SOUTH DUBLIN COUNTY COUNCIL'S PLANNING AUTHORITY'S REPORT TO AN BORD
PLEANALA ON APPLICATION FOR

SUBSTITUTE CONSENT UNDER SECTION 261A

AT BEHAN'S QUARRY WINDMILL HILL, RATHCOOLE

Prepared by: Tracy McGibbon

Figure 4.1

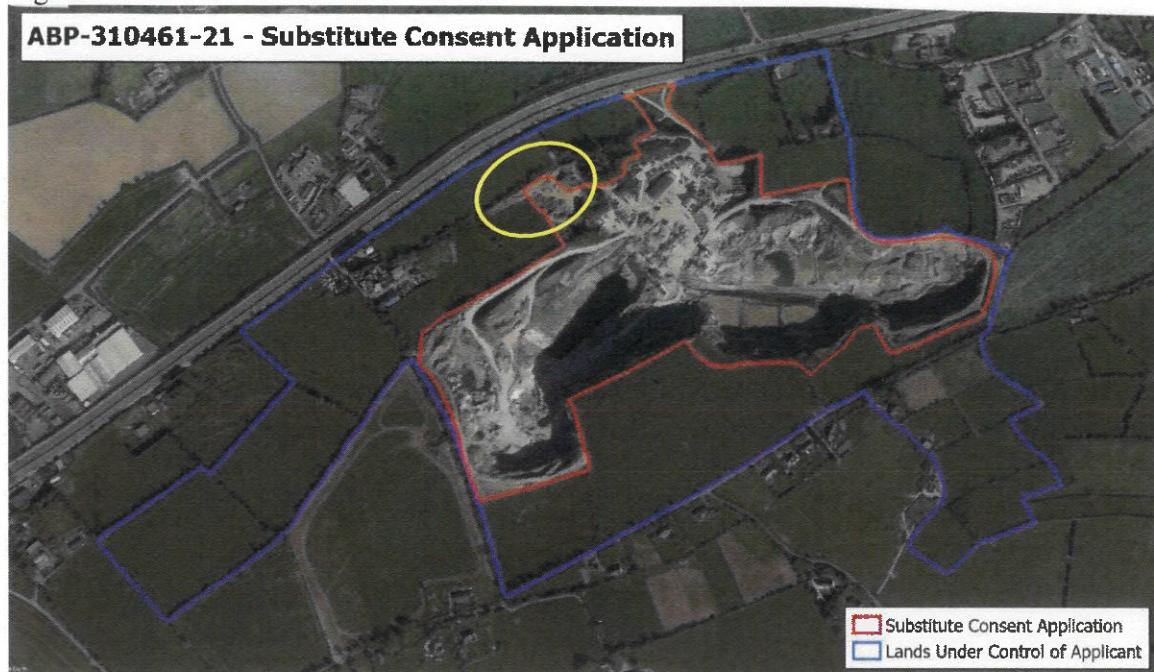
- 4.1 The Planning Authority notes the red line and blue lines as delineated on Site Location Map Project No. 20137776 Drawing No. 02 and would like to draw the Board's attention to works that may be carried out on lands outside of the red line and within the blue line to the north-west of the site. Refer land circled yellow, Figure 4.1.

Figure 5.1

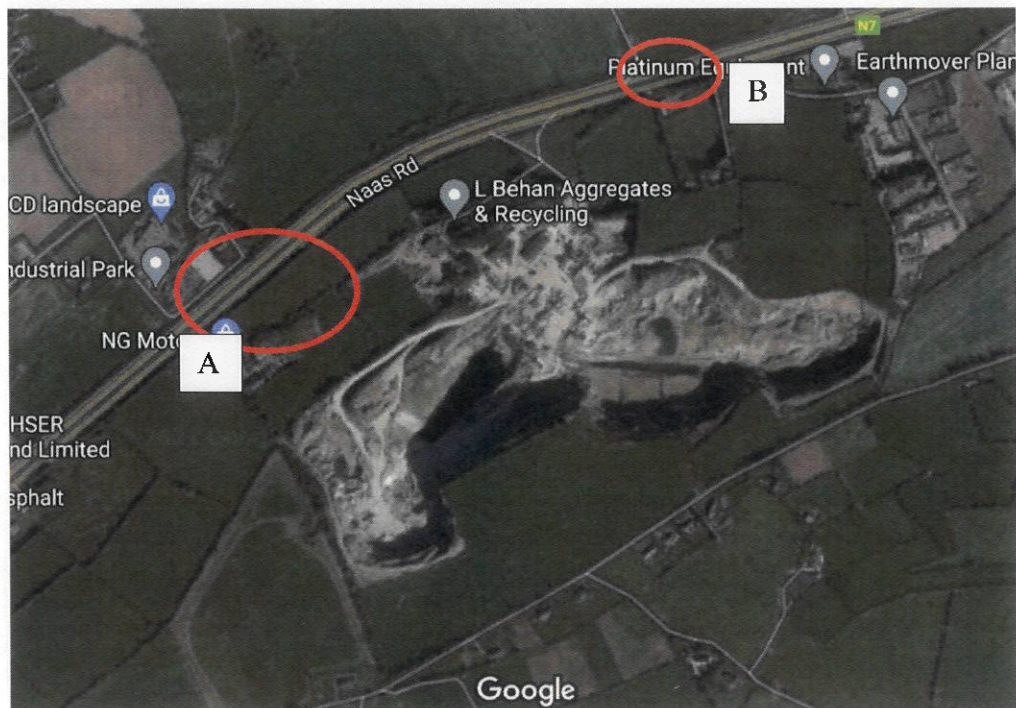
- 5.3 The Planning Authority also notes alleged unauthorised development, works and uses that have taken place on lands outlined in blue located to the north and east of the overall landholding. [Circled and labelled B on Figure 5.1] The site is located off the N7 (with an agricultural entrance in place). The development constructed on site appears to take access off the historic Naas Road, now cul-de-sac'd. No planning history can be traced to these lands and a recommendation has been sent to South Dublin County Council's Enforcement department to investigate these works and uses on rural zoned lands.
